Reply to AirCell September 10, 2004 Response To Telcordia Comments on AirCell Proposals

Dr. Jay E. Padgett
Telcordia Technologies, Inc.
Applied Research
Wireless Systems and Networks

September 24, 2004

Figure 1: Measurements of path loss isolation between aircraft, from Figure A3 of [4].

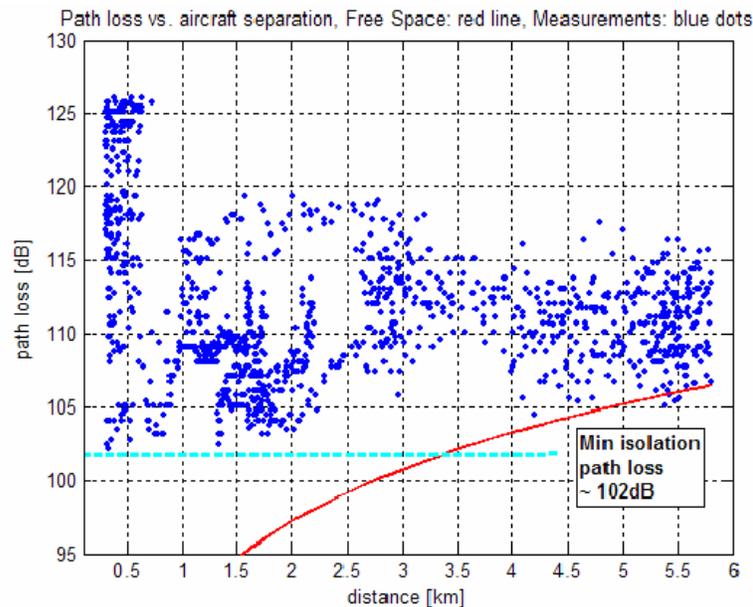
In [3], AirCell took issue with Telcordia's inclusion of a 10-dB system performance margin in the link budget. In [5], Telcordia responded that the 10 dB was based on Airfone's operational experience, and further noted that in Appendix A of [4], AirCell shows air-to-air propagation data that exhibits a significant variation as shown in Figure 1 (the red line represents free space propagation). The point is that often in real-world environments, there are unexpected losses and that it is not unreasonable to expect that similar imperfect link budgets will occur on the air-to-ground link as well, especially in light of the fact that there is the potential for reflections. Telcordia concluded in [5] (p. 4) that "In sum, AirCell's claim that it is not appropriate to include the additional 10-dB margin in the link budget seems inconsistent with its own recently reported measurement data."

AirCell's response in [6] (p. 2) was "The flaw of such a generalization is obvious, since ATG [air to ground] transmission does not suffer from the aircraft shielding/obstruction losses inherent to ATA [air to air] scenarios with aircraft flying at different altitudes." The problem with this argument is that, as discussed in [5], the aircraft vertical separation was only about 1000 feet during the measurements (see [4], p. 72), so at the large end of the distance range (e.g., 5 km horizontal distance), the elevation angle between the two aircraft is only about 3.5°, and blockage effects should not be significant. AirCell completely ignored this point in [6].

Figure 2: Figure 7.1.r from the AirCell flight tests [7].

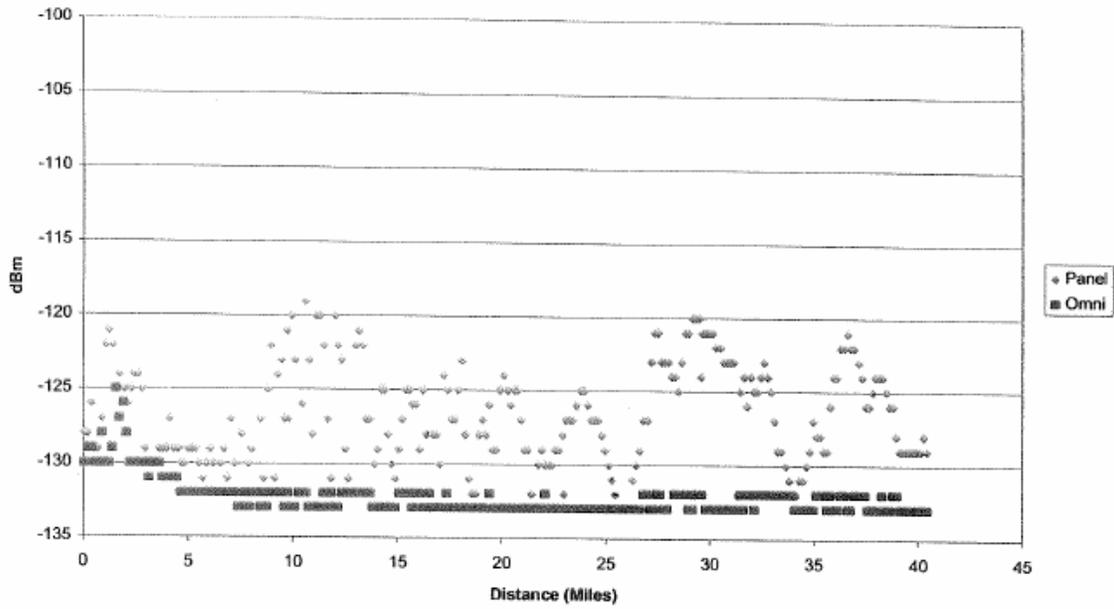
AirCell, with its operational experience, surely must understand the magnitude of the variations that can occur on an air to ground link. Figure 2 and Figure 3 show received power vs. distance plots for the air-to-ground link from AirCell's own flight test report [7]. These plots show variations on the order of 10 dB along most of the flight path. It therefore is difficult to understand why AirCell insists that the air-to-ground link will exhibit textbook free-space propagation.

Figure 4: Geometry for analysis of base-to-base interference for the airport scenario, reproduced from [4], Fig. C.3, page 89.

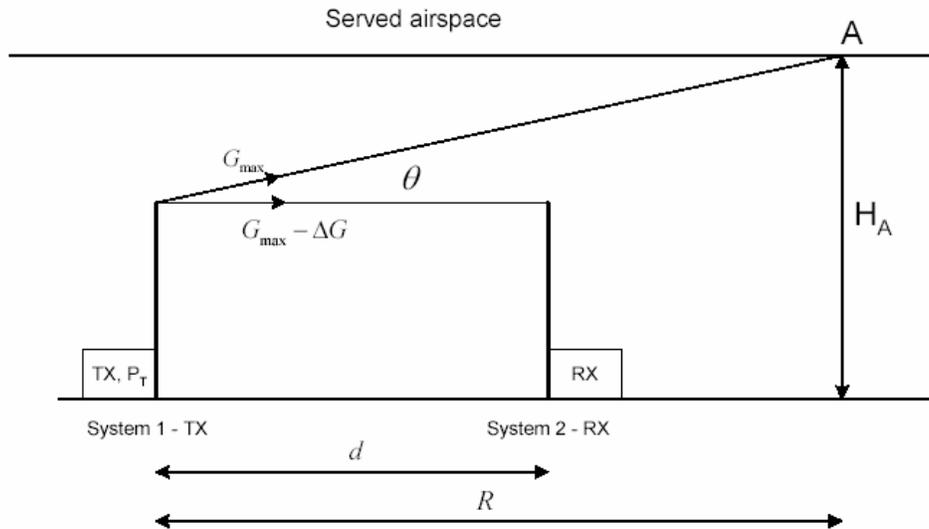
In Table 5.1 on p. 25 of [4], the minimum aircraft altitude is given as 1000 feet for the airport scenario, and the cell radius is given as 12.5 miles. Based on those parameters, the angle θ is less than 1 degree. In table C.2 of [4], AirCell gives the required null depth ΔG as a function of base station separation. For a 10-mile separation, ΔG is about 25 dB, leading to Telcordia's conclusion that the antenna gain must roll off by 25 dB within an elevation change of 1° .

The flaw in the argument made by Telcordia is obvious. Clearly an aircraft flying at an altitude of 1000 ft is either arriving or departing and is not 12.5 miles away from the airport! Under more realistic circumstances, selection of site locations and antenna patterns will allow coverage to be maintained while the base to base isolations are kept at negligible levels [*sic*] ([4], p. 5).

Presumably, what AirCell actually intended to say here is something like “base to base interference is kept at negligible levels.” That aside, however, AirCell completely fails to mention that the geometry and assumptions upon which Telcordia's calculation was based were those provided by AirCell itself in [4], despite the fact that this was clearly explained by Telcordia in [5]. Moreover, AirCell has failed to state what conditions for the aircraft approach might constitute “more realistic circumstances” in terms of approach angle.¹ Further, it should be noted that the 12.5 miles is not necessarily the distance to the runway, but the distance to the base station. In short, AirCell's argument

Figure 5: Modulation efficiency vs. SINR.

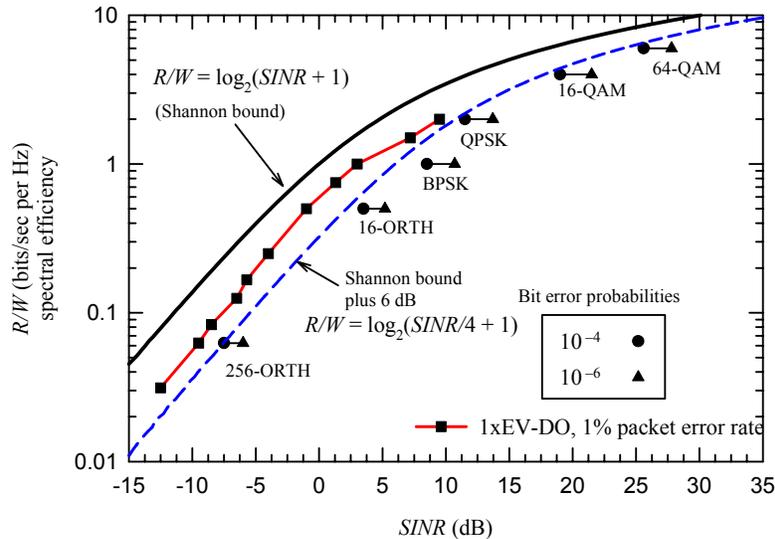
Telcordia observed in [5] that, regardless of technology, increasing the data rate with a fixed transmission bandwidth and a given path loss requires an increase in transmit power. This was supported with the relationships shown in Figure 5. Telcordia then used these relationships to demonstrate the increase in the aircraft EIRP that would be required to support broadband services on the reverse link, compared to the EIRP needed to support the 48 kb/s average throughput in AirCell's analysis.

Figure 6: Required reverse link EIRP vs. data rate, assuming 23 dBm is required to support 48 kbps.

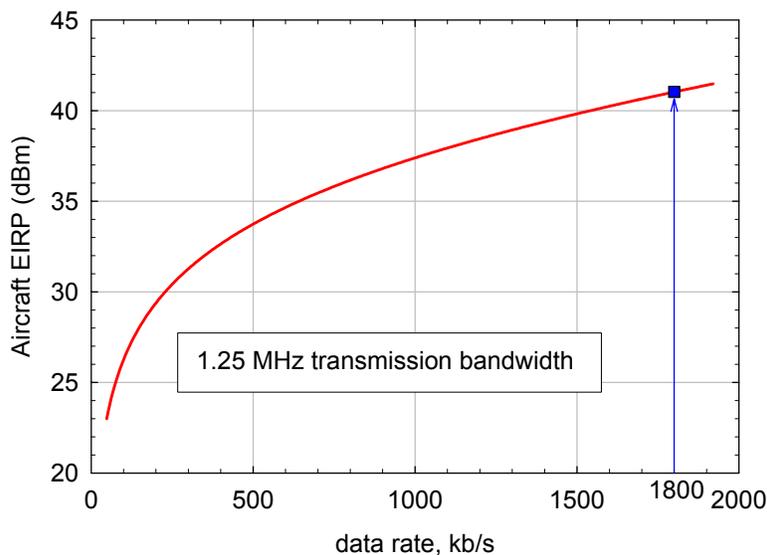
where $W = 1250$ kHz and R is the throughput in kbps. This follows from the same reasoning as eq. (12) of [5]. The result is shown in Figure 6; note that an aircraft EIRP of 41 dBm would be required to support a reverse link rate of 1.8 Mbps, according to this calculation.

Clearly, a hard limit of 23 dBm (0.2 watts) on the aircraft EIRP is inadequate to support broadband transmissions on the reverse link, and in particular, to support the 1.8 Mbps peak reverse link rate of 1xEV-DO rev A. Thus, AirCell’s unqualified endorsement of 1xEV-DO rev A for ATG applications is inconsistent with its proposal to limit the aircraft EIRP to 23 dBm.
